Recall Information Bulletin

No: C1003510 **Issued:** 8/1/2008
NHTSA No: 08V-221
Transport Canada No: 08-171
Re: Rear Engine Support
Group: 32 **Models:** FE

Safety Recall C1003510 - Rear Engine Support

PHOTO 1

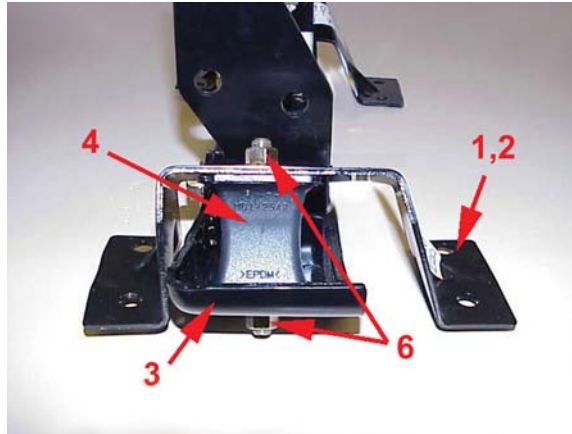
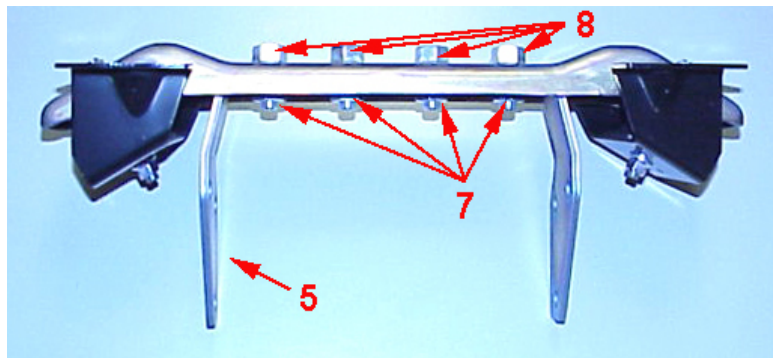
2. Assemble items 1 through 8 of parts kit EX32 into one assembly, as shown in PHOTOS 1 and 2 below.

3. Torque the hardware to the following specifications:

Torque Specifications		
Item #	Part Name	Torque
6	Flange nut (10)	15.5-22.9 ft.lbs. (21-31 Nm)
7	Flange nut (14)	148-199 ft. lbs. (200-270 Nm)

PHOTO 3

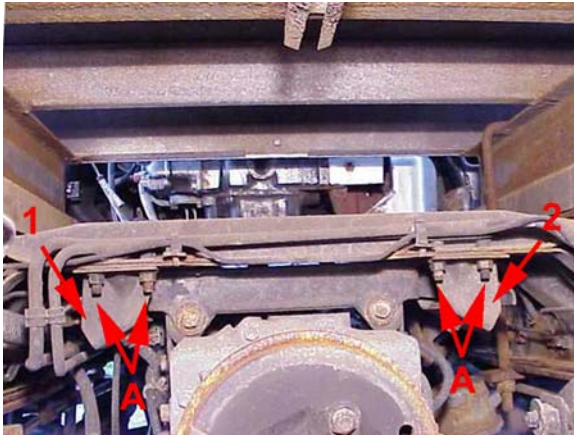
4. Support the A/T assembly with a transmission jack (or similar device). **CAUTION! Support the A/T assembly evenly. Supporting the weight of the assembly unevenly could crush the oil pan.**
5. Remove the engine speed sensor if any specific rear body application presents a clearance problem.
6. Remove the hardware (A) that affixes the left and right hand rear engine mounting brackets (1,2) to the cross member (See PHOTO 3).
7. Remove the flange bolts (11) that affix the transmission mounting bracket (5) to the sides of the A/T assembly (See PHOTO 4). Ensure that the previously unused bolt hole (at A, PHOTO 4) is clear of debris before installing the new bolt.
8. Using the transmission jack (or similar device), lower the A/T assembly to provide adequate clearance for removal of the rear engine support assembly.
9. Remove the old rear engine support assembly.

PHOTO 4

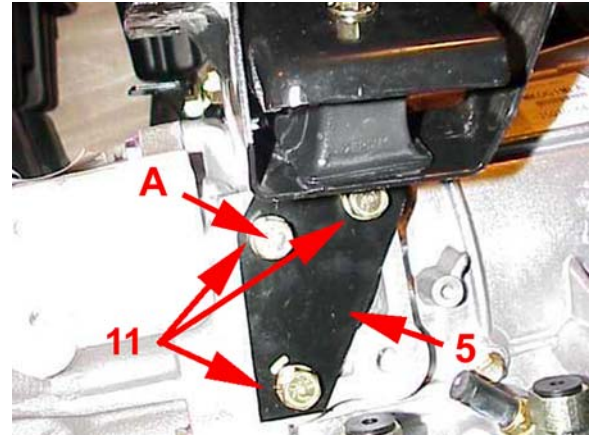
10. With the A/T assembly in the lowered position, affix the new rear engine support assembly to the sides of the transmission (See PHOTO 4) using six new flange bolts (11). Torque the six flange bolts (11) to 47.9-62.6 ft.lbs. (65-85 Nm).
11. Raise the A/T assembly until the rear engine support assembly (3) rests firmly and evenly against the cross member.
12. Install the affixing bolts (9) and nuts (10). Torque the nuts to 36.9-47.9 ft.lbs (50-65 Nm).
13. If the engine speed sensor was removed during Step 5, reinstall it using a new o-ring (12). Torque the affixing bolt to 5.9 ft.lbs (8.0 Nm).
14. Remove the transmission jack, reconnect the battery cables and remove the wheel chocks.
